Consultation Report for

Lisvane Road (Mill Road To Crofta) Section 106

Summary of current identified changes:

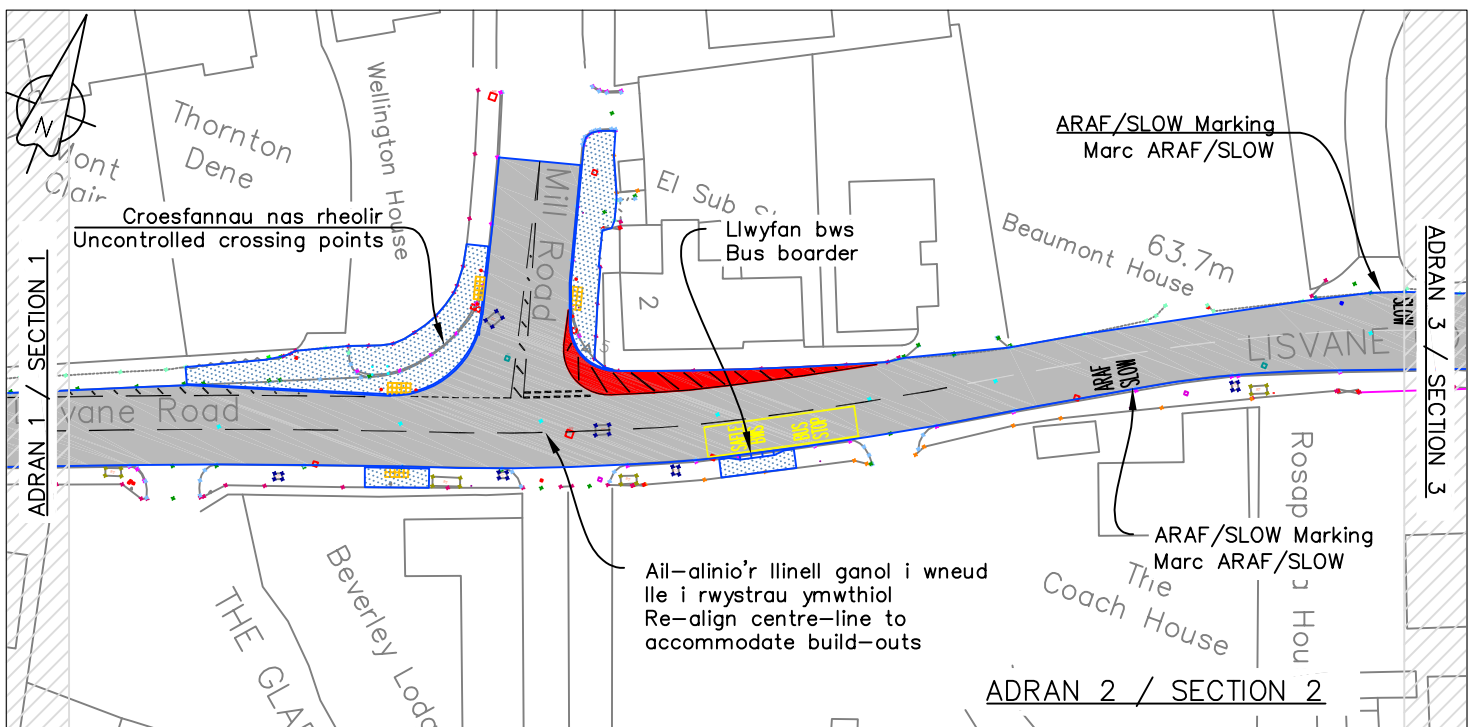
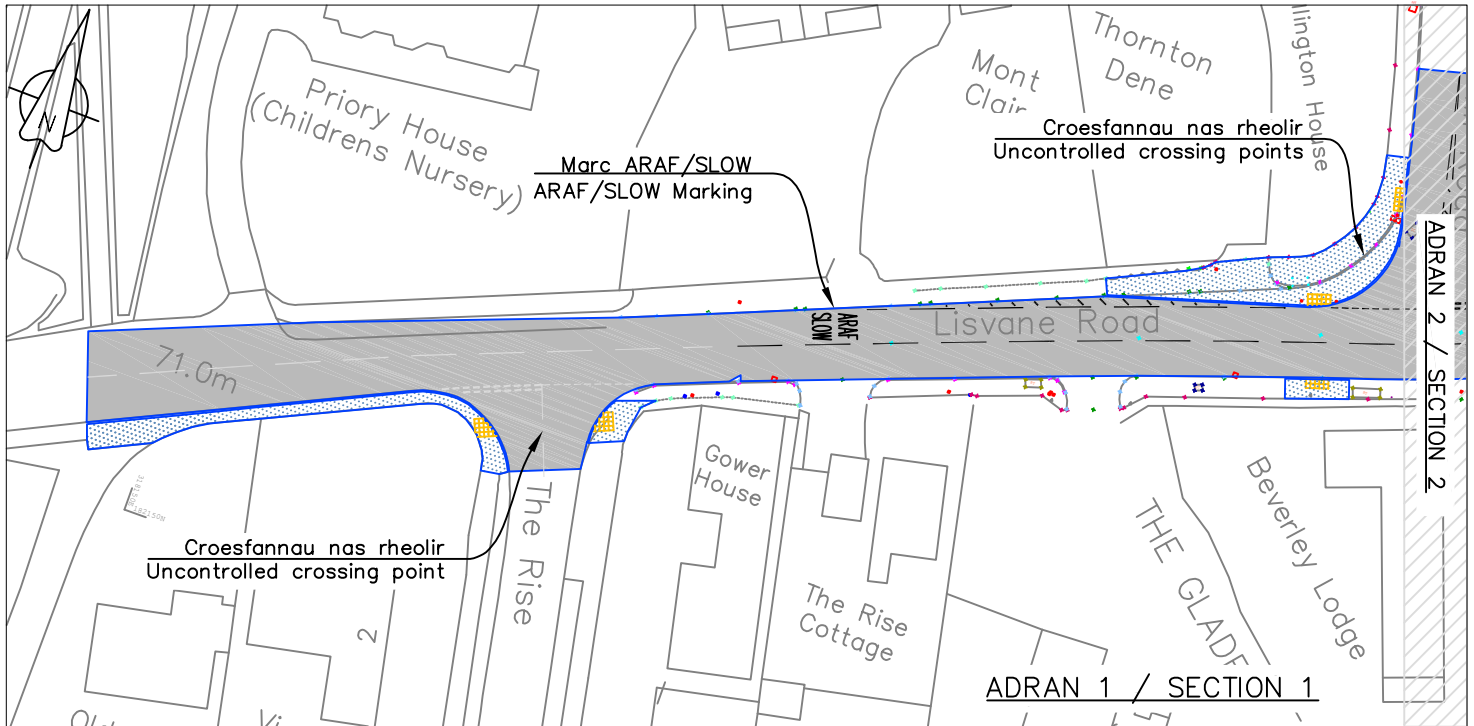
- Signage/lining – additional signage/lining will be considered on the advance to various features where concerns have been raised (as part of the detailed design process),
- Woodside Court – It will not be possible to undertake the full changes proposed at this junction due to the costs associated with relocating buried fibre optic communication services. Further investigation will be undertaken as part of the detailed design process to improve visibility at the junction.
- The bus stop at the Woodside Court Junction will be retained at its current location.
- Mill Road junction, the build-out on the eastern side of the junction has been replaced with a painted build-out to reduce costs.
